**OHIO TURNPIKE AND  
INFRASTRUCTURE COMMISSION**

**ADDENDUM NO. 4**  
**ISSUED NOVEMBER 25, 2019**

**PROJECT NO. 43-19-05 (PART A)**  
**BRIDGE REPAIR AND REHABILITATION**  
**OHIO TURNPIKE RAMP OVER OHIO TURNPIKE M.P. 161.5,**  
**OHIO TURNPIKE RAMP OVER OHIO TURNPIKE M.P. 161.8**  
**CUYAHOGA COUNTY, OHIO – ISSUED NOVEMBER 6, 2019**

**PROJECT NO. 43-19-05 (PART B)**  
**BRIDGE DECK REPLACEMENT AND REHABILITATION**  
**WEBSTER ROAD OVER OHIO TURNPIKE M.P. 162.9,**  
**ABBEY ROAD OVER OHIO TURNPIKE M.P. 164.4**  
**CUYAHOGA COUNTY, OHIO – ISSUED NOVEMBER 6, 2019**

BEARING DETAILS  
 WEBSTER ROAD OVER OHIO TURNPIKE  
 CUYAHOGA COUNTY

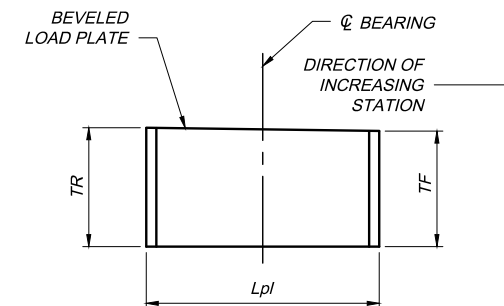
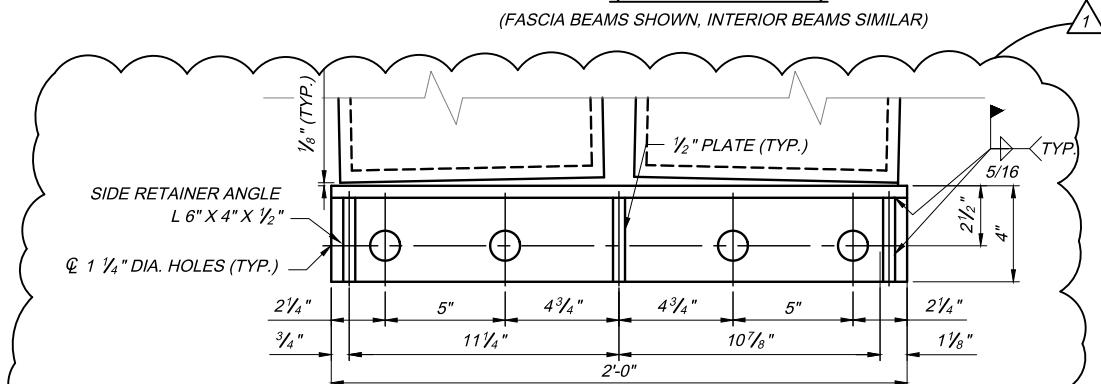
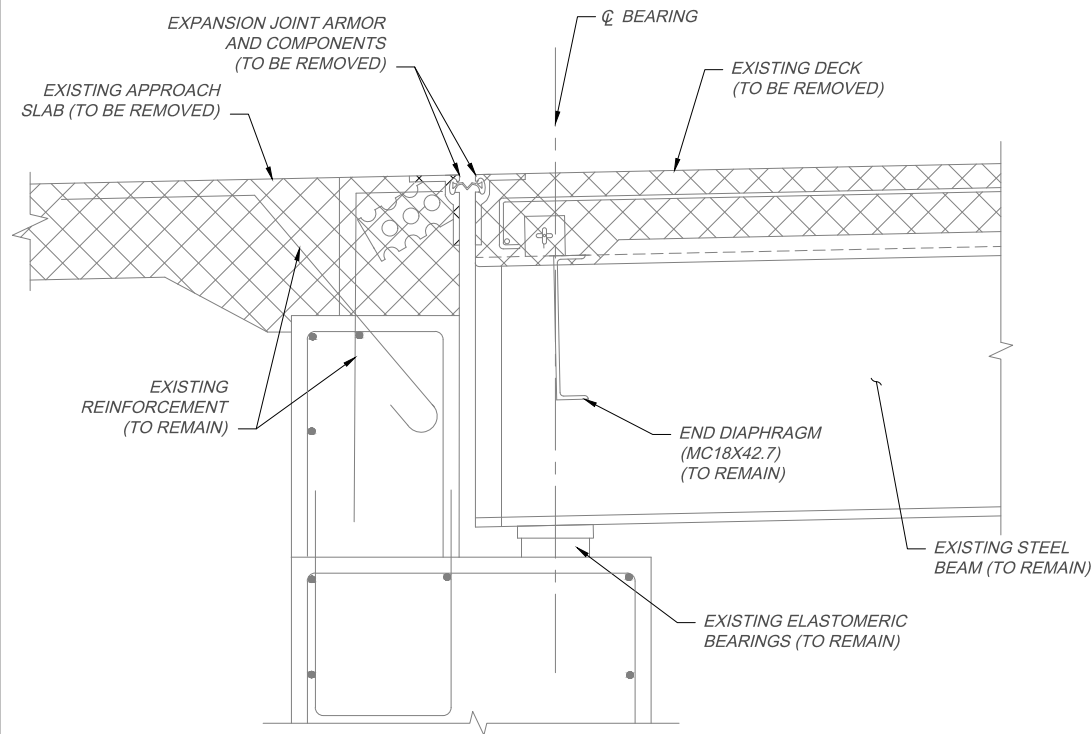
**Q#21 Page 17 of 30 shows the details for the Side Retainer Angle. Please provide additional details on the side retainer including length and number of anchor rods per side retainer angle.**

*A#21 Additional Details for the side retainer angle have been added to Part B Plan Sheet 17 of 30 and is included in this Addendum No. 4.*

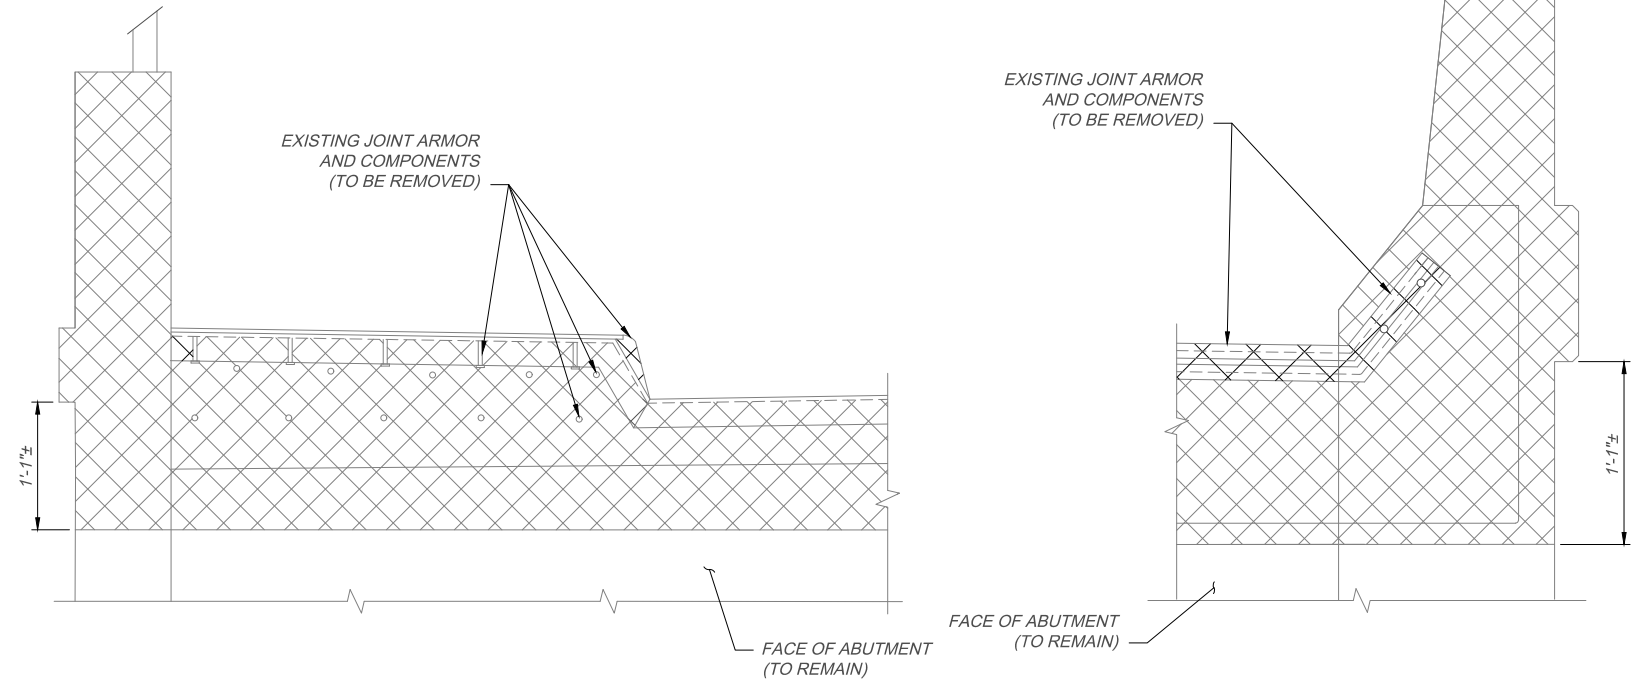
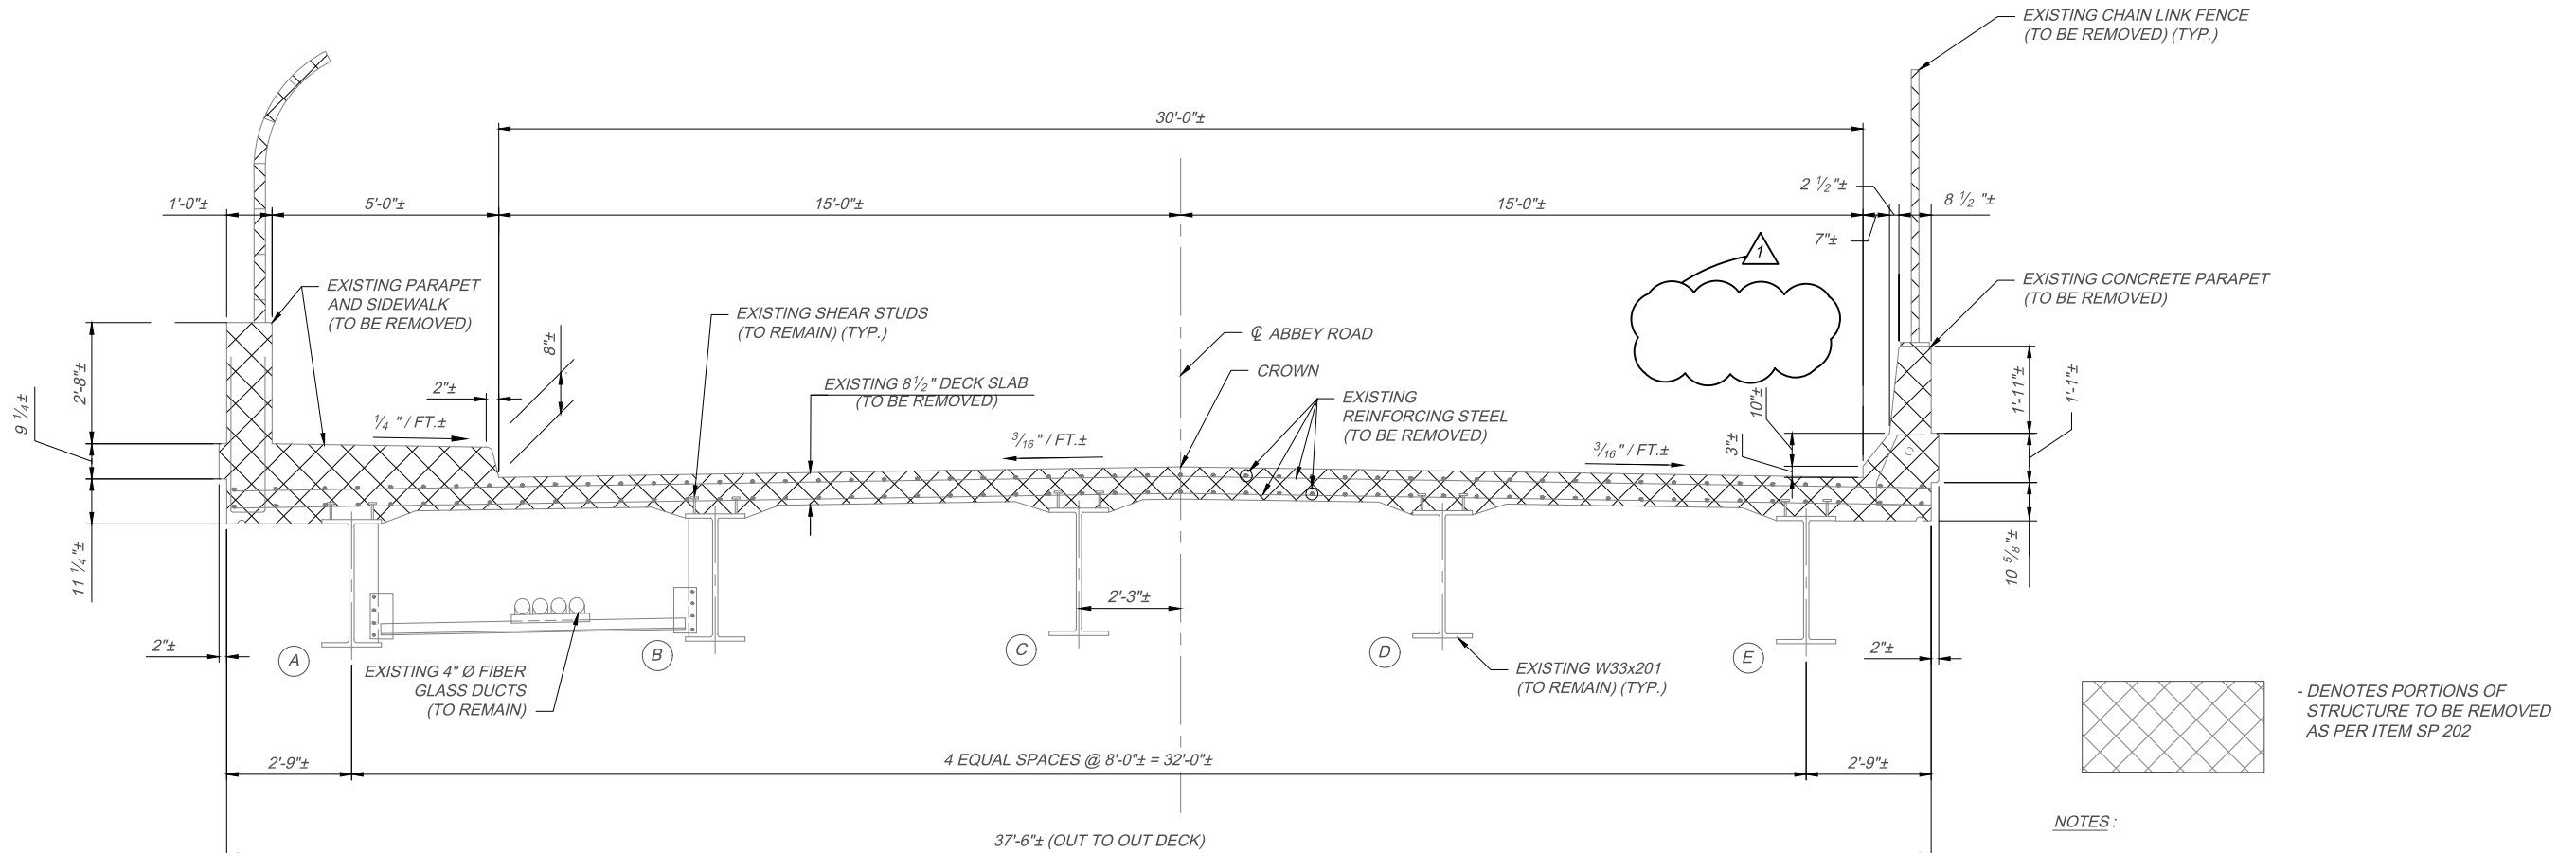
**Q#11** On sheet 22/30, it calls for the existing 2” conduit in the right parapet to remain. This is not possible to do and still demo the parapet. Furthermore, it is not shown in the proposed transverse section for the bridge. Please confirm if this conduit needs to be saved; and if it does please confirm if new conduit can be run in the proposed parapet in lieu of saving the existing.

*A#11 The existing 2” conduit does not need to remain. Plan Sheet 22 of 30 has been revised and is included as part of this Addendum No. 4.*
